Access Compliance Report

Public Rights-of-Way

(Curb Ramps)

Intersection ID: 48953	Main Street: DAVID_JENNINGS_AV	Cross Street: GATESMILLS_AV	Location: NE
ADA ID: FFF65FB87980	Ramp Type: Perp	Initial Pass/Fail: Fail	Overall Compliance: No
Severity Score: 10			
Codes/Mitigation Info/Possible Solution		Field Measurements/Component Compliance

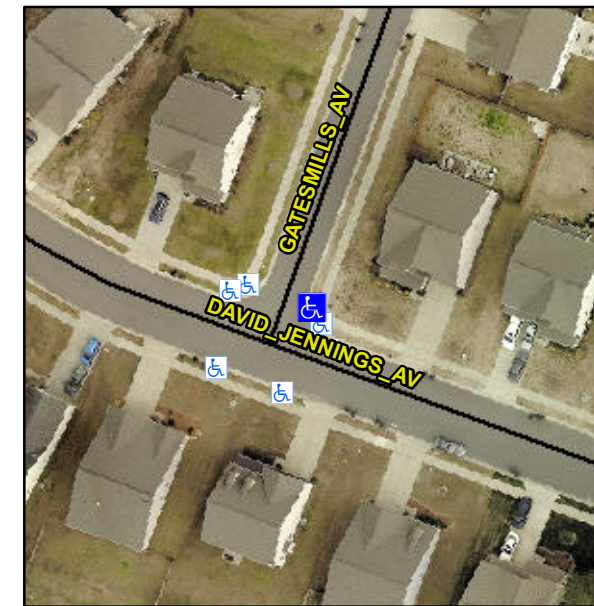
Not Found, R304.5.1, R304.5.3

Compliance	Description	Data	Compliance	Description	Data
N/A	Ramp Length (in)	44.5	Yes	Ramp Slope (%)	5.8
No	Ramp Width (in)	47.5	No	Ramp XSlope (%)	2.2
N/A	Flare Type LT	N/A	N/A	Flare Type RT	N/A
N/A	Flare Slope LT (%)	N/A	N/A	Flare Slope RT (%)	N/A
N/A	Flare Traversable LT?	N/A	N/A	Flare Traversable RT?	N/A
N/A	Landing Length (in)	N/A	N/A	DWS Provided?	N/A
N/A	Landing Width (in)	N/A	N/A	DWS Contrast?	N/A
N/A	Landing Slope (%)	N/A	N/A	DWS Length (in)	N/A
N/A	Landing X Slope (%)	N/A	N/A	DWS Full Width?	N/A
N/A	Landing Curb? (Y/N)	N/A	N/A	DWS Offset (in)	N/A
N/A	Shared Landing?	N/A			
N/A	Gutter Ponding?	N/A	N/A	Gutter Slope (%)	N/A
N/A	Gutter Lip Ht (in)	N/A	N/A	Gutter X Slope (%)	N/A
N/A	Painted X Walk1?	No	N/A	Painted X Walk2?	N/A
	X Walk 1 Direction	To NW		X Walk 2 Direction	N/A
N/A	X Walk 1 Width (in)	N/A	N/A	X Walk 2 Width (in)	N/A
	X Walk 1 Slope (%)	0.9		X Walk 2 Slope (%)	N/A
	X Walk 1 X Slope (%)	4.4		X Walk 2 X Slope (%)	N/A

Remove & Replace Entire Ramp.
